30/13-04B 10935 Montrose Ave Garrett Park Historic District

SUBJECT: Historic Area Work Permit #___359061___

HISTORIC PRESERVATION COMMISSION STAFF REPORT

Proposal for 10935 Montrose Ave, Garrett Park, MD20896

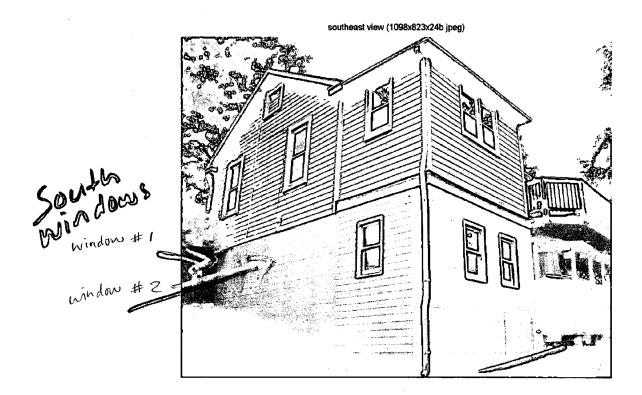
revisting: 33×24 New: 28×48 (equess)

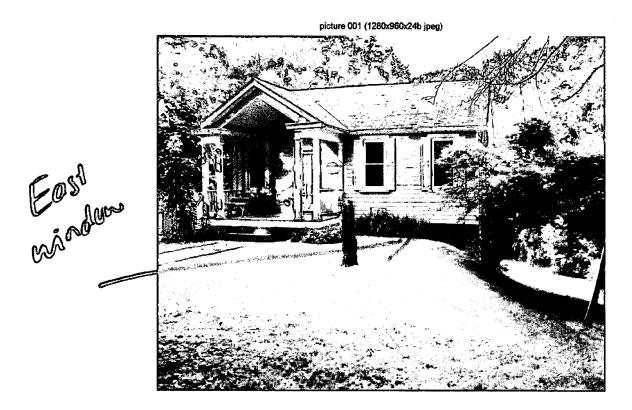
existing: 33×12 new: = 30×20

, Elevations Before + After

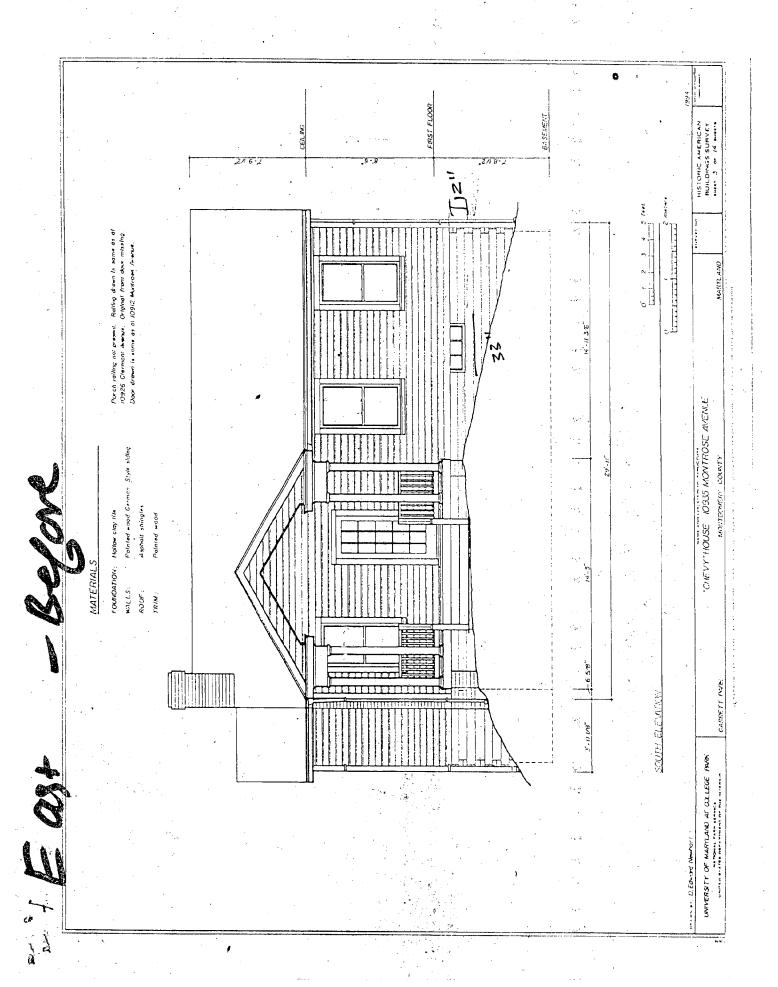
The applicants are proposing the following new windows and window openings: two 28" wide x 48" tall windows on the right side (existing windows are 24" x 33"), one 30" wide x 20" tall window on the front of the house (existing window is 33" x 12"), and on the left side one window measuring 28" x 20" (existing is 33" x 12").
